JAMES THOMAS BARNES SUBDIVISION,
REVISED RESUBDIVISION OF

APPLICATION NUMBER 8 DATE March 18, 2010

REQUEST Subdivision

DETAIL SITE PLAN

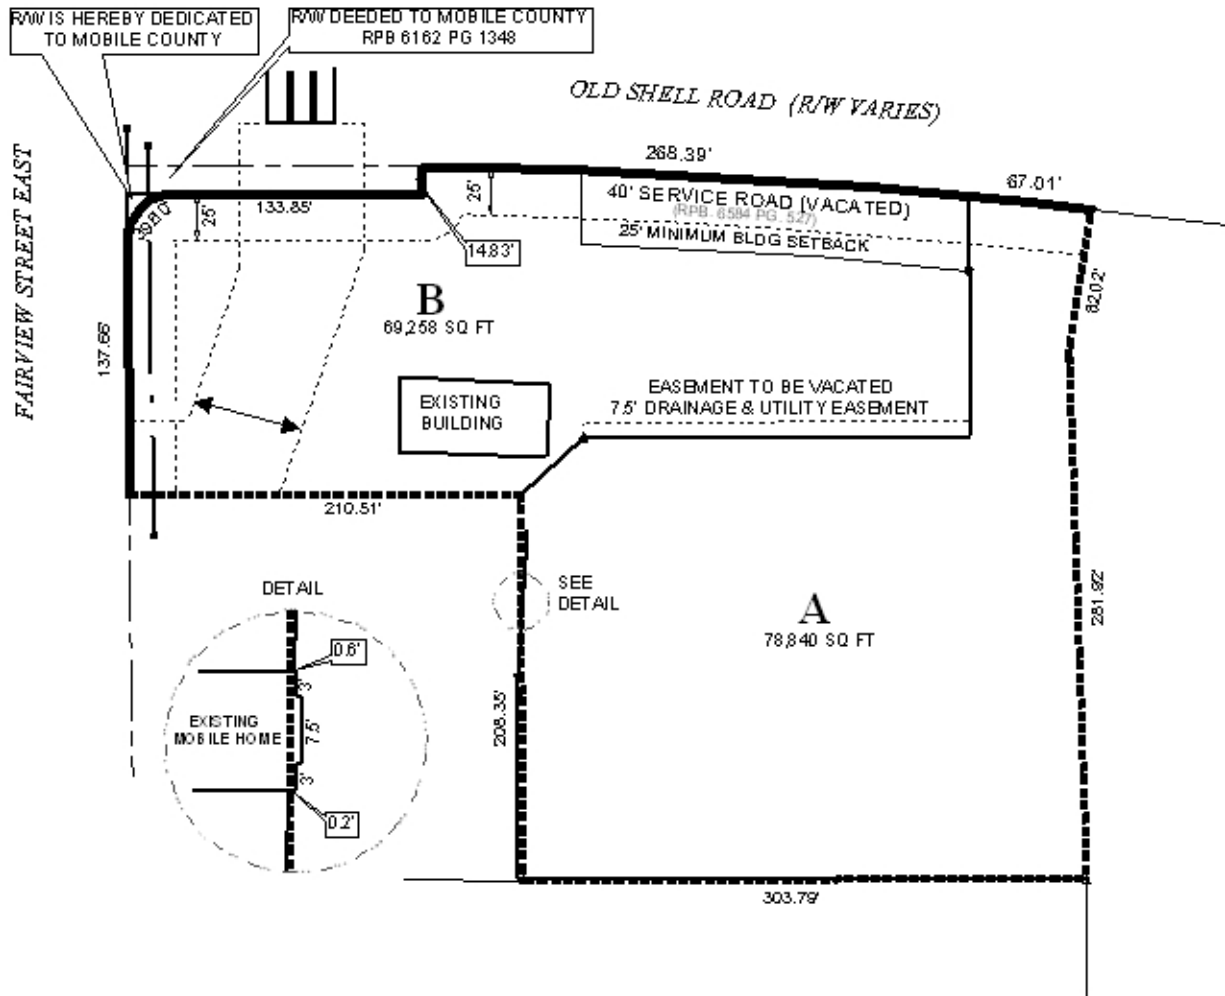
The recorded plat of the Resubdivision of James Thomas Barnes Subdivision includes a note limiting Lot A to one curb cut, and Lot B to two curb cuts to Old Shell Road, with the size, location and design of all curb cuts to be approved by County Engineering. This should also be required on the Final Plat, with the addition that the curb cuts must conform to AASHTO

standards. A note on the plat states that Lot B is denied access to Fairview Street East until it is improved to County standards; this should also be required on the Final Plat but expanded to require curb cut size, location, and design to be approved by County Engineering.

The 25' minimum building setback lines along Old Shell Road and Fairview Street East are indicated on the plat and should also be included on the Final Plat. Additionally, the lot sizes in square feet are labeled on the plat and should also be labeled on the Final Plat with the addition of the lot sizes in acres, or a table depicting the same information should be provided.

The plat includes a note stating that any lots which are developed commercially and adjoin residentially developed property must provide a buffer, in compliance with Section V.A.8. of the Subdivision Regulations. This note should also be required on the Final Plat.

- 1) placement of a note on the Final Plat stating that Lot A is limited to one curb cut, and Lot B is limited to two curb cuts to Old Shell Road, with the size, location and design of all curb cuts to be approved by County Engineering and conform to AASHTO standards;

- 2) placement of a note on the Final Plat stating that Lot B is denied access to Fairview Street East until such time it is improved to County standards. Upon improvement to County standards, Lot B is limited to one curb cut to Fairview Street East, with the size, location and design to be approved by County Engineering;

- 3) illustration of the 25' minimum building setback line along Old Shell Road and Fairview Street East;
- 4) labeling of the lots with their sizes in square feet and acres, or the furnishing of a table on the Final Plat providing the same information;

- 5) placement of a note on the Final Plat stating that any lots which are developed commercially and adjoin residentially developed property must provide a buffer, in compliance with Section V.A.8. of the Subdivision Regulations;
